## Design Review Report – Item 1

Item no.: Item 1 – PDA25/0058 – 22 Muriel Avenue, Innaloo – Pre Development Application – Mixed Use

Date: 20 November 2025 Time: 2pm

Drawing Title:  
FF Solar Study

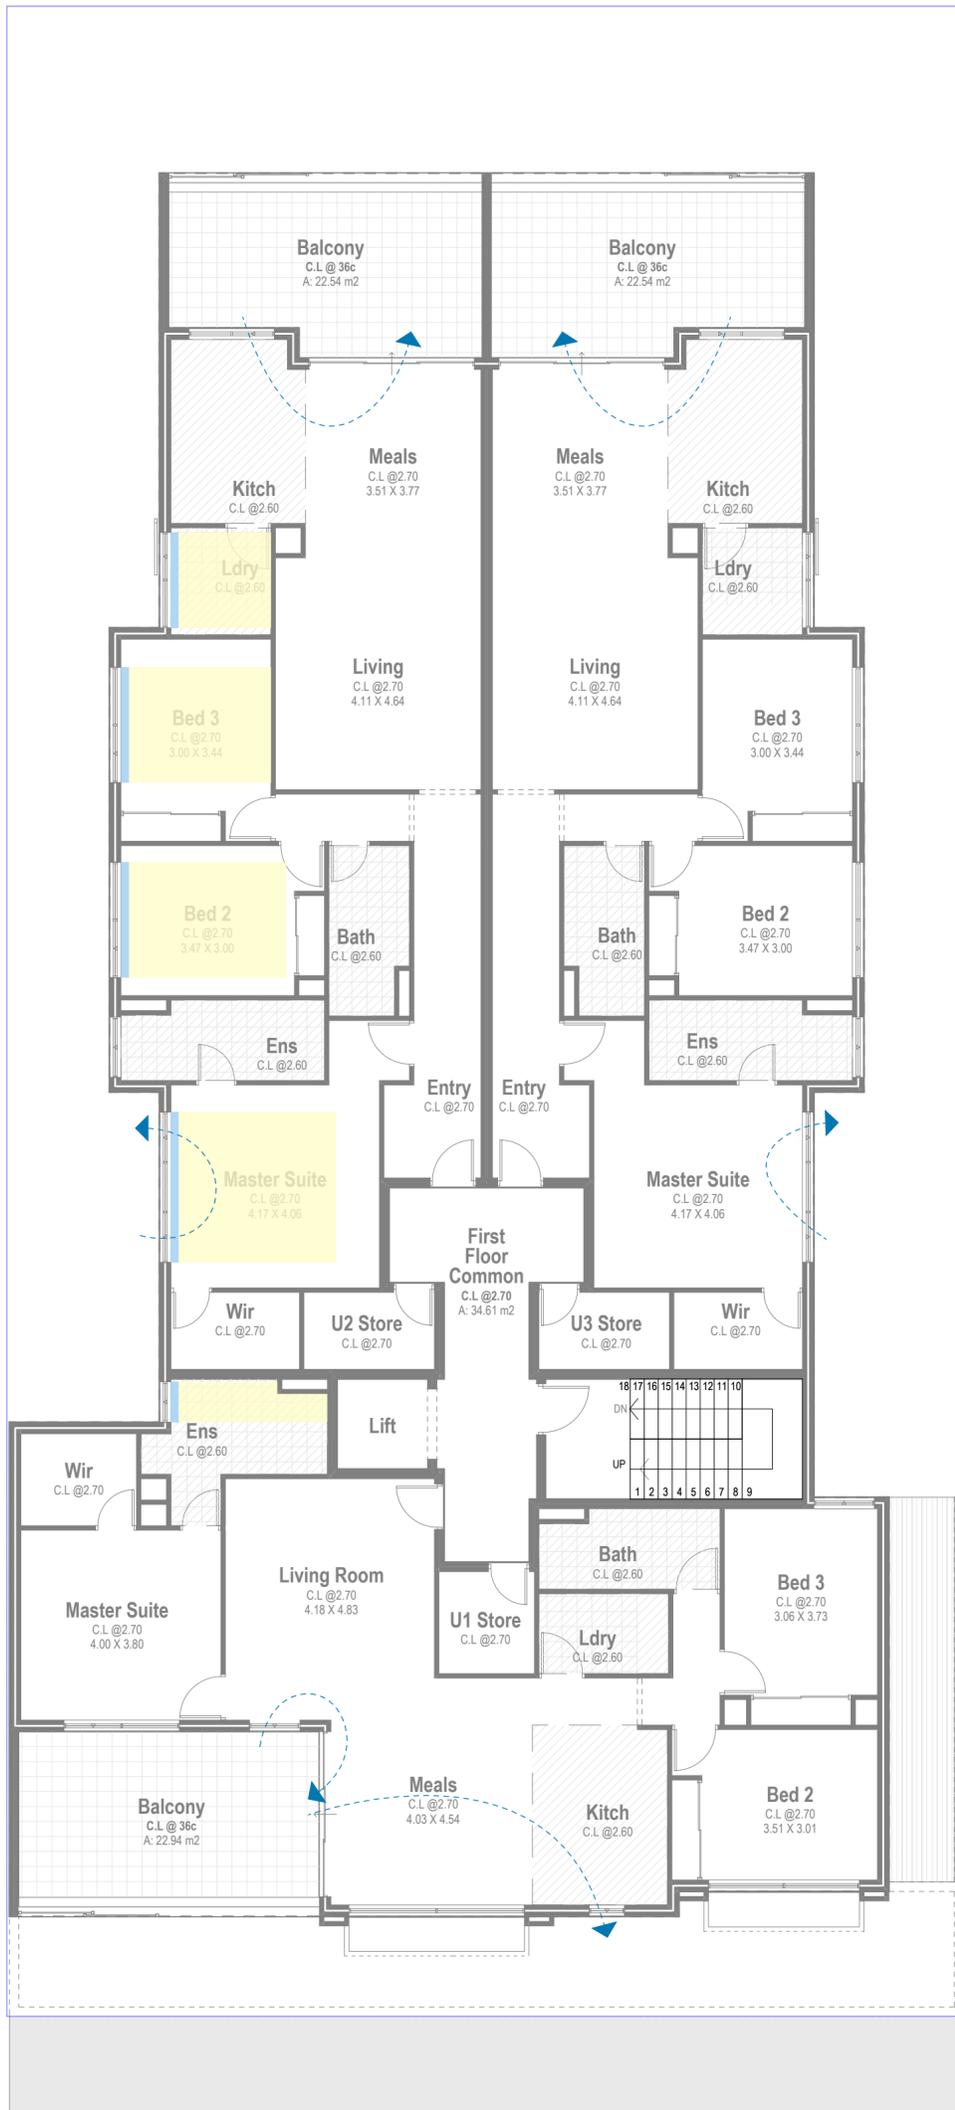
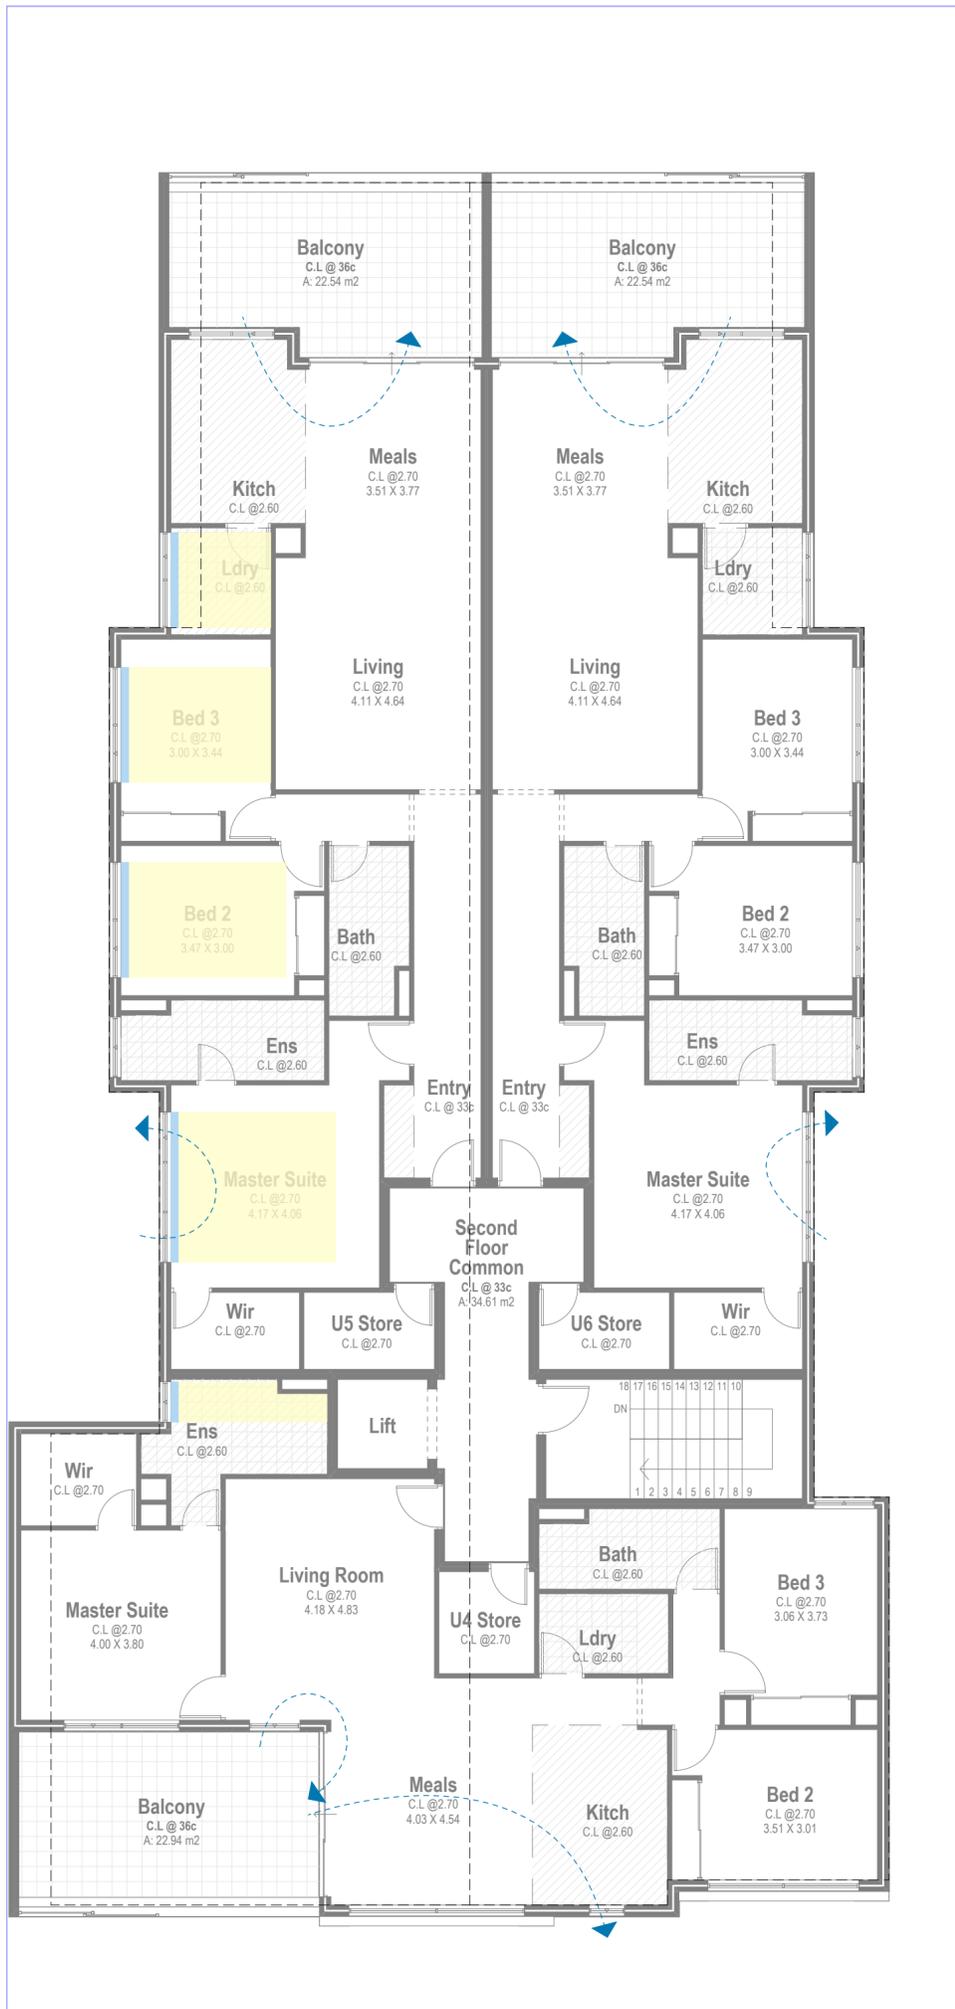
<p>4c. It was suggested by the Panel a window or open stairs could be introduced to the enclosed lobby and lift area. Another suggestion was to push the lift further north to create more space here as it feels tight.</p> <p>4d. It is also likely that the lift will require an overrun so would be good to show it on the plans.</p> <p>4e. The gun-barrel design of the long corridor leading to the lift requires further consideration, particularly regarding the placement of mailboxes and opportunities to encourage incidental encounters between residents. From the current design, having a shared corridor and lobby between the commercial and residential areas may not be necessary. Separating these spaces could improve privacy, reduce potential conflicts, and provide residents with a greater sense of security.</p>			
<p>5a. Comment was made by the Panel further detailed information is required around sustainability and this principle was only briefly indicated.</p> <p>5b. The Applicant was encouraged to explore sustainability initiatives and make a strong commitment at Development Application stage via a consolidated sustainability statement to demonstrate the adopted initiatives including potential future provisions for EV as practical</p> <p>5c. It is recommended a solar study is provided to ensure solar access can be established.</p>

PROJECT		DRAWING				ISSUE		REVISIONS			
22 MURIEL AVE		CAR PARK PLANITNG PLAN				ISSUED FOR FEEDBACK		No	DATE	DRAWN	DETAILS
CLIENT		DRAWING NO	SCALE	SHEET	REVISION	DRAWN	DATE	0	24/10/25	NK	CAR PARK PLANTING- ISSUED FOR FEEDBACK
		L-01	1:75	A1	0	NK	24/10/25

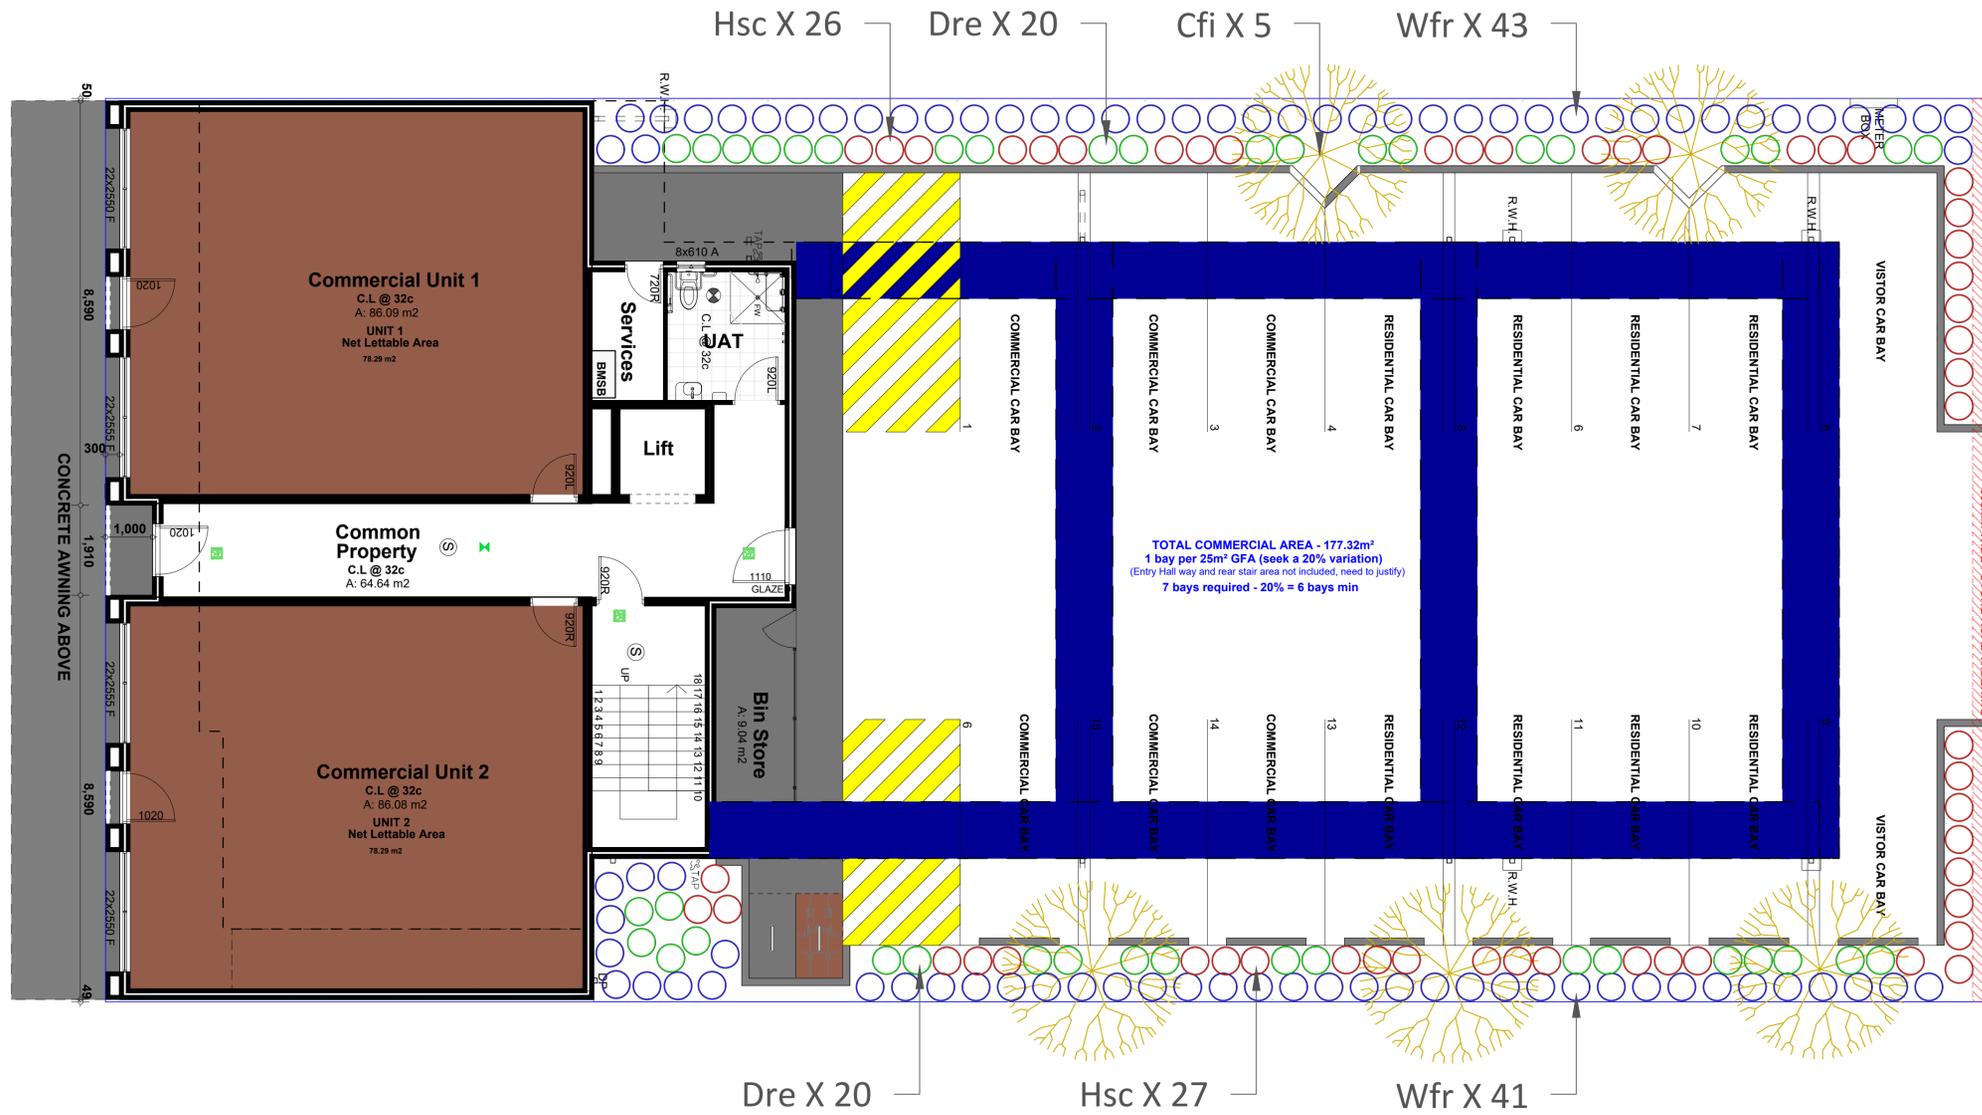
<b>Principle 2</b> <b>Landscape quality</b>		<i>Good design recognises that together landscape and buildings operate as an integrated and sustainable system, within a broader ecological context.</i>
	N	<p>2a. It was stated by the Panel there is currently limited information around the shared pavement areas and no separately defined pedestrian route. It was suggested clearly defined paving for pedestrians would be beneficial in the shared spaces.</p> <p>2b. The Panel requested swept path movements to ensure turning circles are sufficient.</p> <p>2c. It was recommended by the Panel additional trees could be planted on the north and west side of the development.</p> <p>2d. It was stated the curb upstands in the carpark area don't seem to connect to the medium that separates the carpark. It was noted there is opportunity to utilise this area and create a parklet in this location.</p> <p>2e. Comment was made by the Panel some of the landscaped areas are heavily shaded and the shrub and ground cover species chosen are not well adapted to heavy shade and have insufficient space.</p> <p>2f. It was mentioned the <i>Corymbia Ficifolia</i> tree is high on the Polyphagous shot hole borer list and should not be used.</p> <p>2g. Comment was made by the Panel the concrete awning is not supported by the Panel and this should be replaced with a steel frame awning under the City's policy</p> <p>2h. It was mentioned the Fig tree creates excessive shade which will affect light penetration to the balconies. It was suggested reconsidering the additional planters in this location as they will contribute to the lack of sunlight.</p> <p>2i. The Panel noted there are no metrics on the landscape plan and these will be required.</p> <p>2j. It was suggested additional landscaping could be included on the balconies towards the laneway.</p> <p>2k. It was suggested there is potential to introduce additional on structure landscaping.</p>

<p>2l. Comment was made the planter boxes are not accessible and maintenance will be difficult. It was recommended it should be determined who is maintaining these.</p> <p>2m. It was noted by the Panel the pavement north of the UAT is not providing any benefit and the Applicant should consider reorientating this paving.</p> <p>2n. The proposal does not appear to achieve the target of 10% deep soil. Additionally, the proposed landscape areas are either inaccessible, of limited use, or located in less prominent or poorly visible locations—for example, the garden area between the commercial unit, stairs, and bike store is tucked away, inaccessible, and not visible from the commercial unit.</p> <p>2o. While the suspended planting at the upper level contributes to greenery at the frontage, its maintenance will rely on strata to ensure it is properly cared throughout the seasons. Consideration should also be given to access, safe and fall protection.</p> <p>2p. To increase deep soil target and communal amenity, a roof terrace may be an option to be considered.</p>
